Advertisement Questions

June 5, 2024

VDOT Project No.: 0011-102-728, P101, R201, C501, UPC 105309
Project Name: Lee Highway Widening – Phase 1B
Capital Project No.: 95735

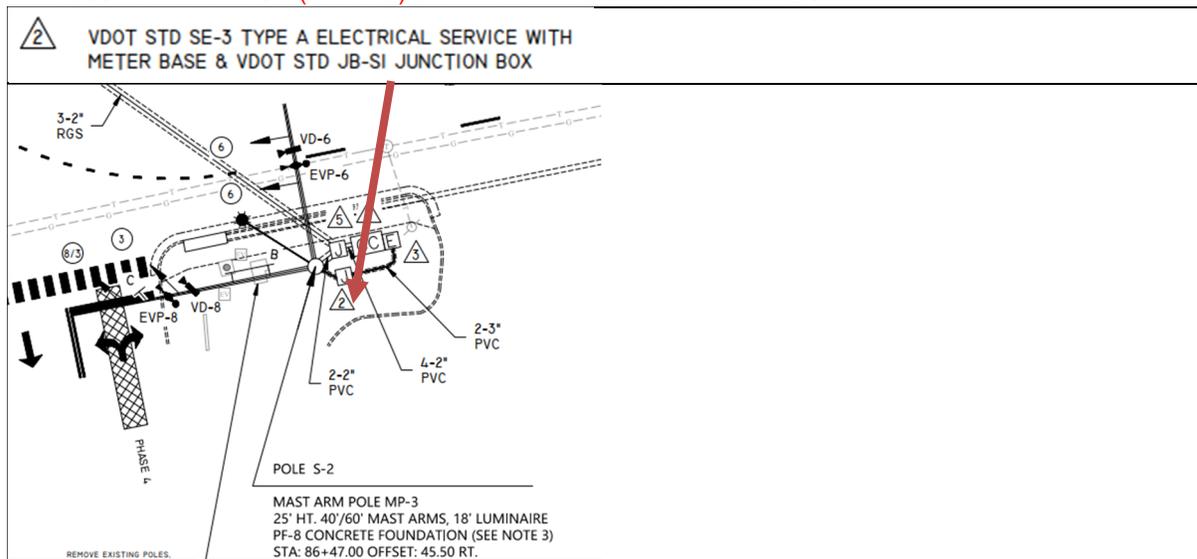
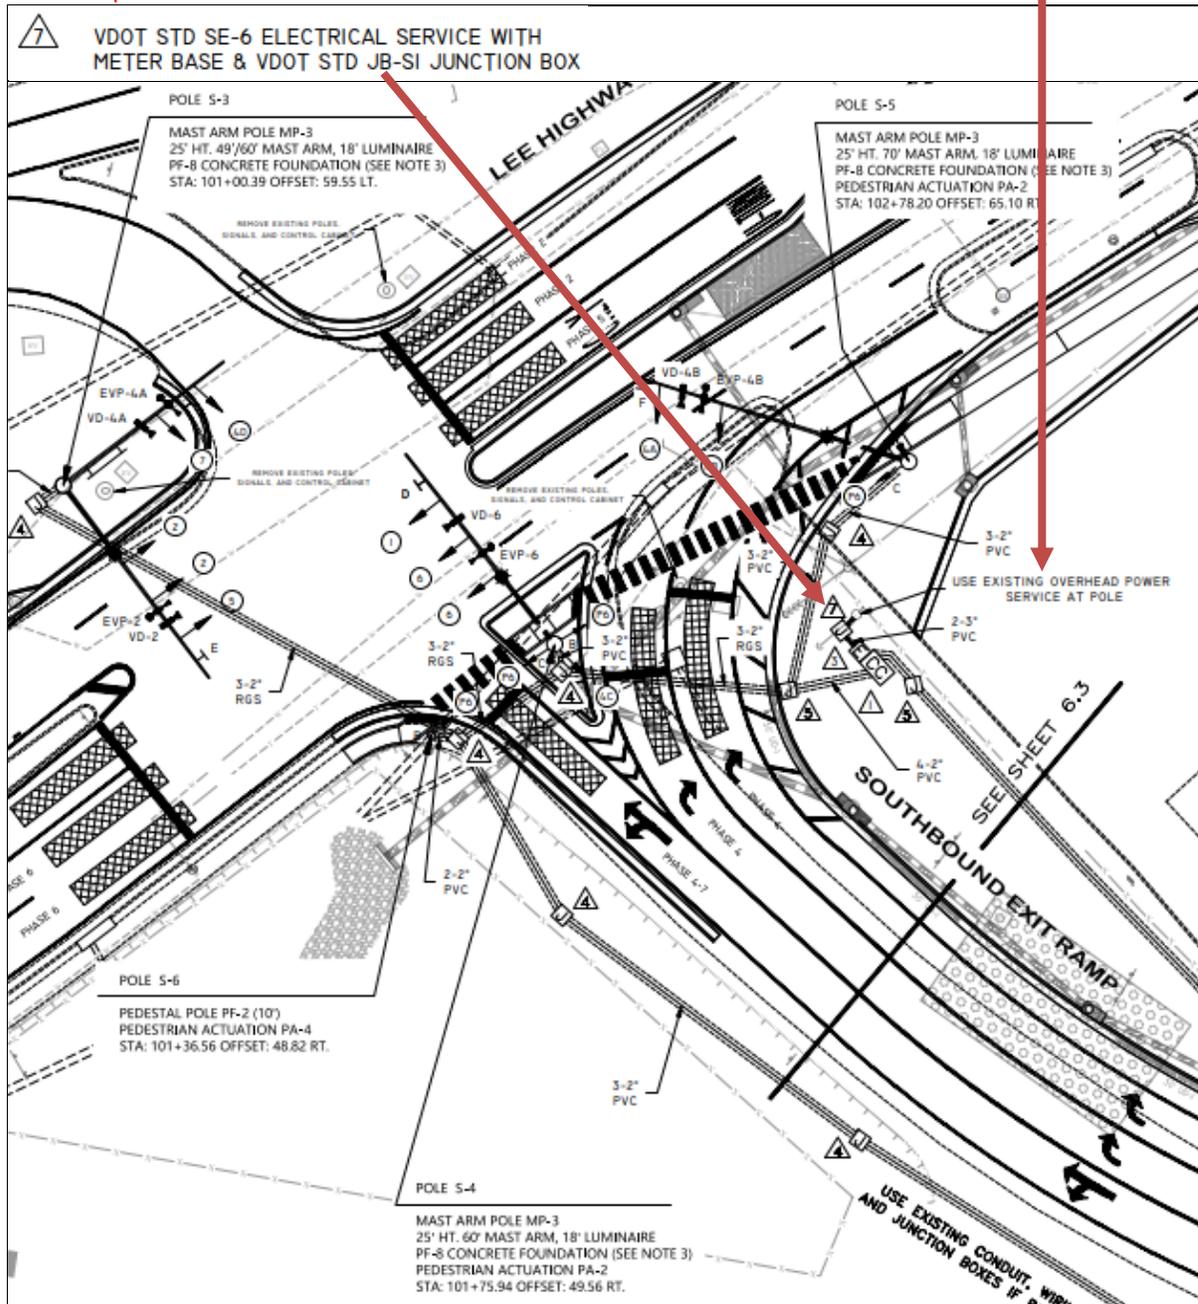
12. Please clarify the electrical service for bid item 1260(1), 1460(1), and 1470(1). Plan sheet 6.2 & 6.4 call for SE6's on them.

Item 1260 – Plan sheet 6.2 (Pole S-2) denotes 1 each Electrical service SE-3

Item 1460 – Plan sheet 6.3 (Poled S-3, S-4, and S-5) denotes 1 each Electrical service SE-6 using the existing overhead power service as main feed

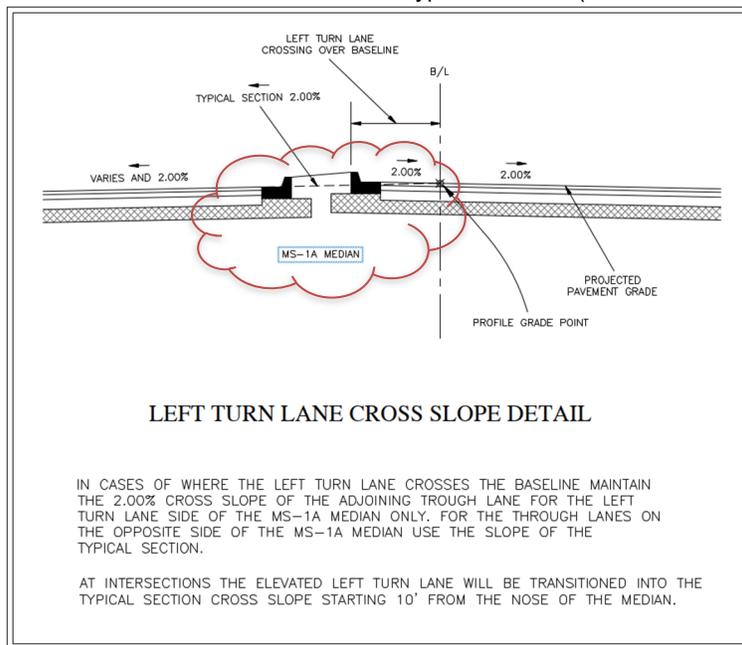
21. Line No. 470 (Item 21020 Median Strip MS-1)

This is denoted and delineated on the typical sections (Plan Sheet 3.4).
